RE: Objective Design Standards

Re: Supplemental San Mateo Objective Design Standards (ODS) Comments

Re: San Mateo Objective Design Standards (ODS) Comments

Figure 21: Possible ways to divide a horizontal mass into three elements (Section 4.1.4).

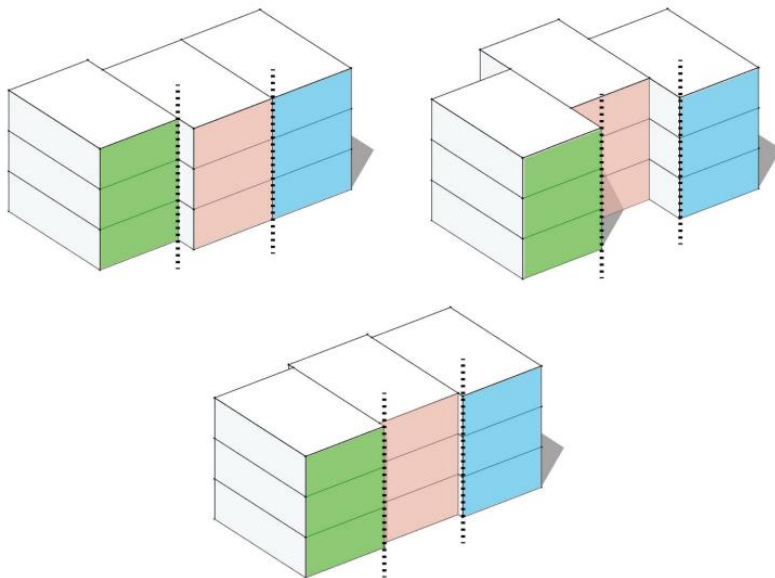
Section 4.1.4 requires that structures of three (3) or more stories must follow the rule of thirds and divide the structure into at least three primary masses. In addition to the changes recommended by the Planning Commission, we also recommend providing clear flexibility to determine the width of the primary masses, and *not* to require each to be exactly one-third of the structure. Such a requirement could unintentionally constrict potential uses and design programs. Instead, the standard could include a minimum percentage of overall façade length (i.e., require the minimum width of each primary mass to be at least 20% of the overall façade length). In addition, this requirement should also specify a minimum two (2) feet change in plane between each massing break to assure that the breaks are more than perfunctory.

Accordingly, we recommend the following revisions to Section 4.1.4 and the removal and/or replacement of Figure 21:

Structures of three (3) or more stories (measured from existing grade) shall ~~follow the rule of thirds in which a structure is~~ be divided into at least three primary masses, where each primary mass is separated by at least a two (2) foot minimum change in plane between each massing break, and where each primary mass shall contain a minimum width consisting of at least twenty (20) percent of the overall façade length. ~~Possible ways to break a horizontal mass into three elements are illustrated below.~~
